JVC

A-GX3

DIAGRAM MANUAL

6. A-GX3 Schematic Diagram

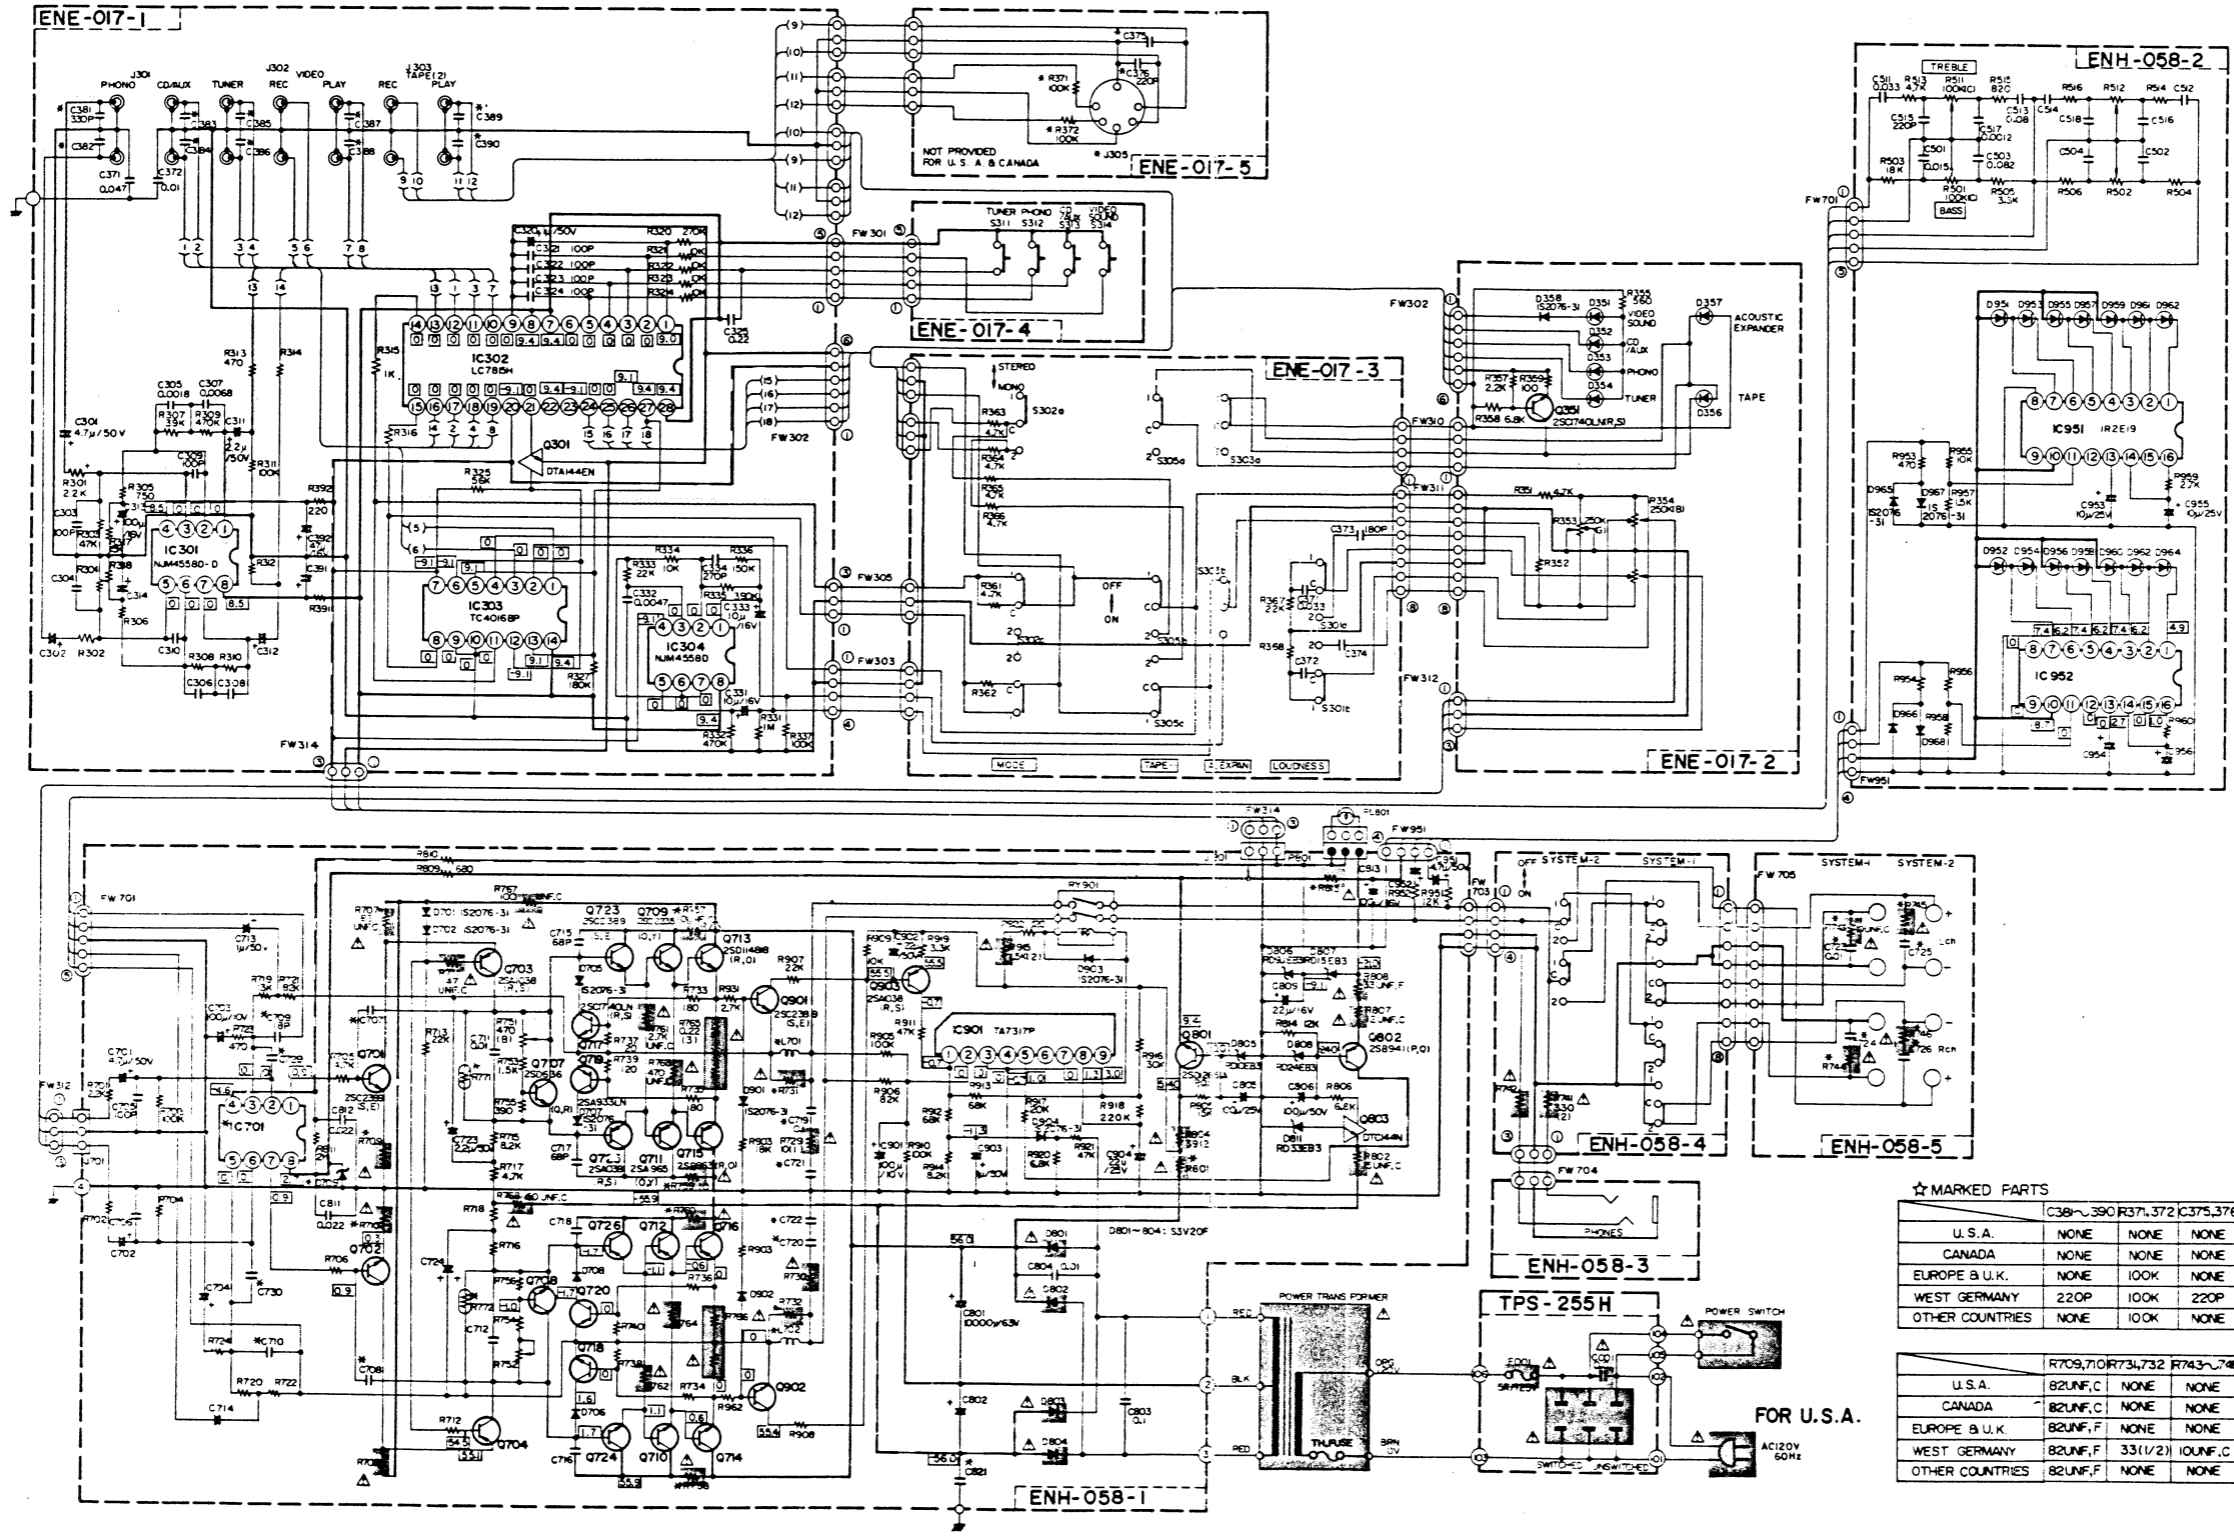
Note:
If the illumination pilot lamp (PL801) for the wind screen is damaged by opening and shortening, do the following:

- (1) Confirm that the parts with the symbol Nos. shown in the table below are defective.
- (2) Replace the diode (D807).

Symbol No.	
R707, 708, 709, 710	82Ω (1/4W)
Q701, 702	2SC2389 (S, E)
R808	33Ω (1/4W)
R802	15Ω (1/4W)

(2) Modification of the diode (D807)
RD12EB3 - RD15EB3
